# Coastal Access – Silecroft to Silverdale

## Representations on SCS 6: Kents Bank to Cove Well, Silverdale - and Natural England's comments

March 2024

Photos From [redacted]

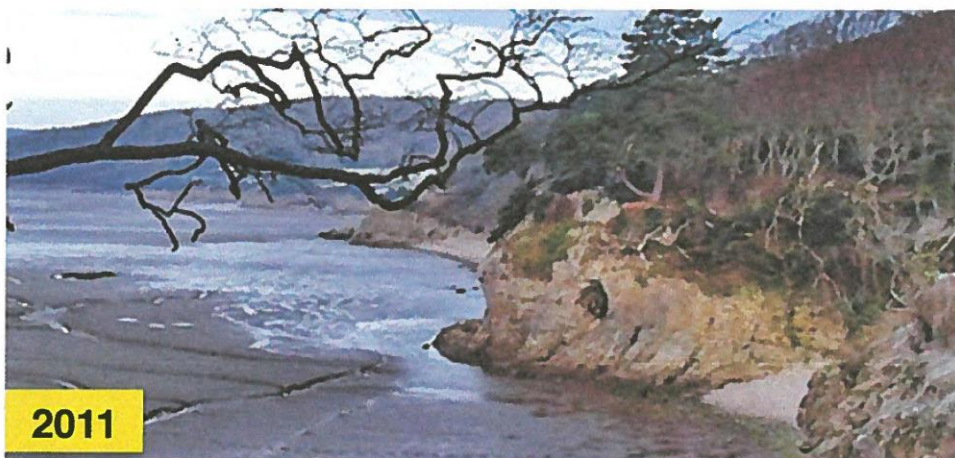
The following images show the view from The Cove to Far Arnside over the years.

Firstly the acres of Saltwashed turf from Silverdale to Arnside Point via The Cove during the 1960's to 1990s.

Secondly a close-up of the Kent channel at The Cove at low tide in 2011 showing how everything had been scoured away.

Thirdly the same section under 8 feet of mud and sand in 2020 which is gradually becoming incremented and consolidated.
